Des Moines Independent Community School District

PROJECT: Brubaker & Hoyt HVAC Improvement

PROJECT NUMBER: 20-061 / 20-063

DATE: February 2, 2021

SHEET M2.1 – MAIN LEVEL PLAN – HVAC EAST

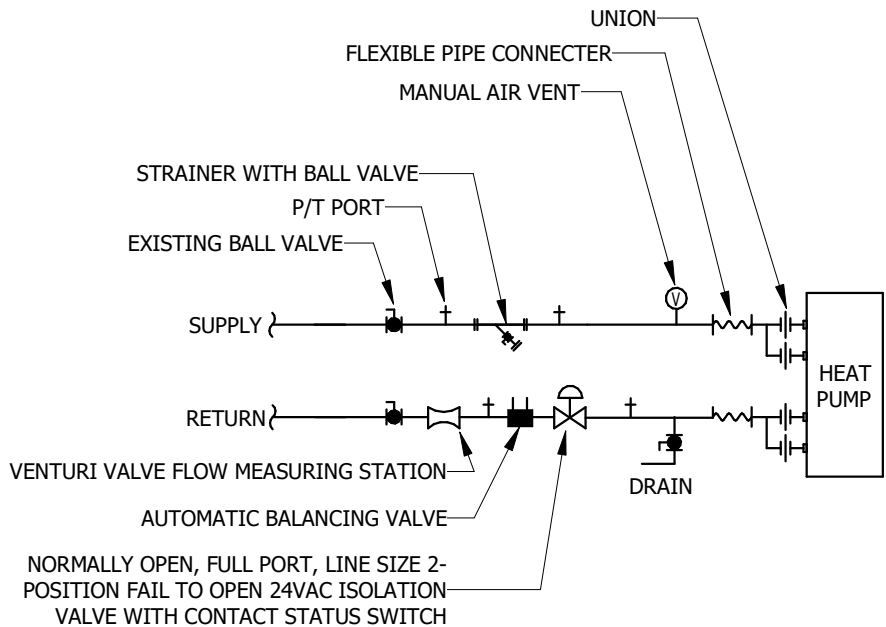
1. Mech A108
 - A. **REMOVE** HP-15-3 as this heat pump does not exist.
 - B. **REMOVE** reference note #2.
 - C. **ADD** existing water cooled VRF unit to remain.
2. Toilet A109a
 - A. **REMOVE** S2 supply diffuser and associated supply ductwork from heat pump main.
